Permit No. 20-199849

LOT 265

Greenpark
project name: RUSSELL GARDENS PHASE 3
date: SEPT. 2020
checked by: _____
scale: 1:250
drawing no.: 19014-RC3-SITE-LAYOUTS
file name: 19014-RC3-SITE-LAYOUTS.dwg
date: Oct. 13, 2020
time: 10:19 AM

lot/block no.: 265
registered plan no.: 62M-1266
project no.: 19014
drawing no.: 1

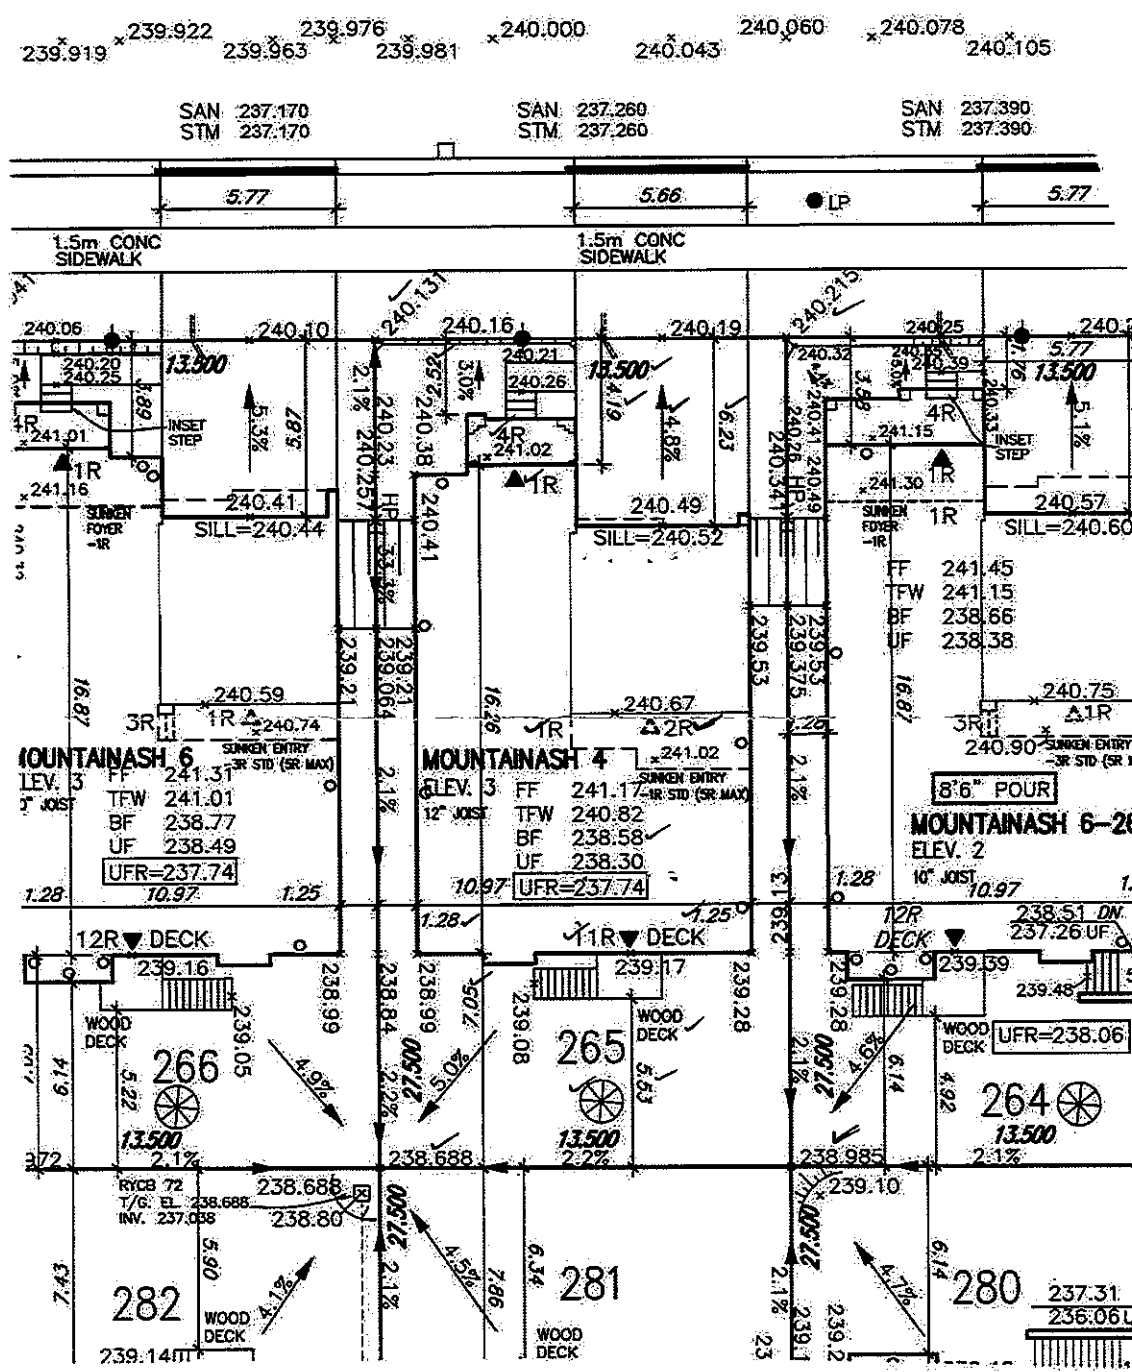
THIS LOT GRADING PLAN HAS BEEN REVIEWED BY METROPOLITAN CONSULTING INC. FOR CONFORMANCE WITH THE APPROVED SUBDIVISION GRADING DESIGN. THE PROPOSED GRADES ON THIS PLAN ARE IN GENERAL CONFORMANCE WITH THE APPROVED GRADING PLAN AS IT RELATES TO THIS LOT AND ADJACENT LOTS. WHERE THE BASEMENT FLOOR OR OTHER FOUNDATION ELEVATIONS ARE PROPOSED AT A DIFFERENT ELEVATION THAN THAT SHOWN ON THE APPROVED SUBDIVISION PLANS THE SEWER LATERALS HAVE BEEN REVIEWED AND WE ARE SATISFIED THAT THE MINIMUM GRADES FOR THESE LATERALS CAN BE MAINTAINED IN ACCORDANCE WITH THE REQUIREMENTS OF THE O.B.C. AND CITY DESIGN CRITERIA. NOTE: THIS CERTIFICATION DOES NOT REPLACE THE BUILDER'S RESPONSIBILITY TO EXPOSE THE SEWER LATERALS AND CONFIRM ELEVATIONS PRIOR TO EXCAVATING FOR THE FOUNDATION. BY USE OF THIS PLAN THE BUILDER AGREES THAT THEY SHALL BE RESPONSIBLE FOR IMMEDIATELY REPORTING TO METROPOLITAN CONSULTING ANY DISCREPANCY OR VARIATION BETWEEN THE LATERAL INFORMATION AND GRADES DEPICTED ON THIS PLAN AND THE CONDITIONS FOUND IN THE FIELD.
